Access Compliance Report

Public Rights-of-Way

Intersection ID: 22868	Main Street: KALANCHOE_DR	Cross Street: SARDIS_POINTE_RD	Location: NW
ADA ID: 8E4E7FBDC0E1	Ramp Type: Perpendicular Diagonal	Initial Pass/Fail: Fail	Overall Compliance: No
		Severity Score: 25

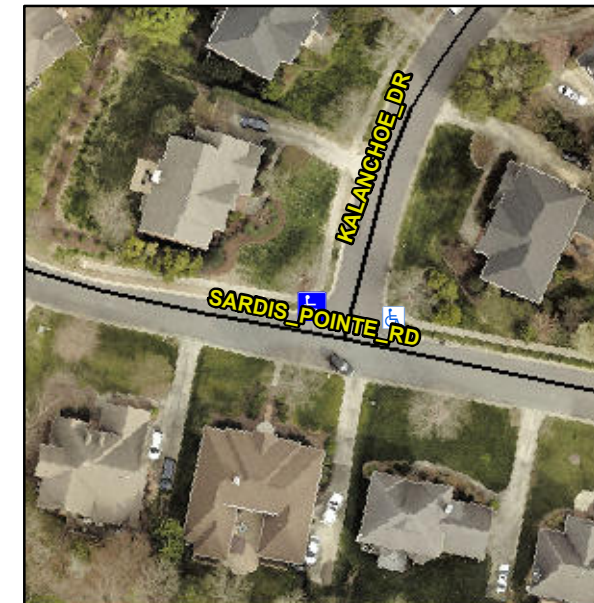
R304.5.3

Compliance	Description	Data	Compliance	Description	Data
N/A	Ramp Length (in)	51.0	Yes	Ramp Slope (%)	6.8
Yes	Ramp Width (in)	48.0	No	Ramp XSlope (%)	8.0
N/A	Flare Type LT	N/A	N/A	Flare Type RT	N/A
N/A	Flare Slope LT (%)	N/A	N/A	Flare Slope RT (%)	N/A
N/A	Flare Traversable LT?	N/A	N/A	Flare Traversable RT?	N/A
N/A	Landing Length (in)	N/A	N/A	DWS Provided?	N/A
N/A	Landing Width (in)	N/A	N/A	DWS Contrast?	N/A
N/A	Landing Slope (%)	N/A	N/A	DWS Length (in)	N/A
N/A	Landing X Slope (%)	N/A	N/A	DWS Full Width?	N/A
N/A	Landing Curb? (Y/N)	N/A	N/A	DWS Offset (in)	N/A
N/A	Shared Landing?	N/A			
N/A	Gutter Ponding?	N/A	N/A	Gutter Slope (%)	N/A
N/A	Gutter Lip Ht (in)	N/A	N/A	Gutter X Slope (%)	N/A
N/A	Painted X Walk1?	No	N/A	Painted X Walk2?	No
	X Walk 1 Direction	To SW		X Walk 2 Direction	To SE
N/A	X Walk 1 Width (in)	N/A	N/A	X Walk 2 Width (in)	N/A
	X Walk 1 Slope (%)	0.5		X Walk 2 Slope (%)	4.7
	X Walk 1 X Slope (%)	5.1		X Walk 2 X Slope (%)	2.9

Remove & Replace Curb Ramp With Two New Directional Ramps or Equivalent.
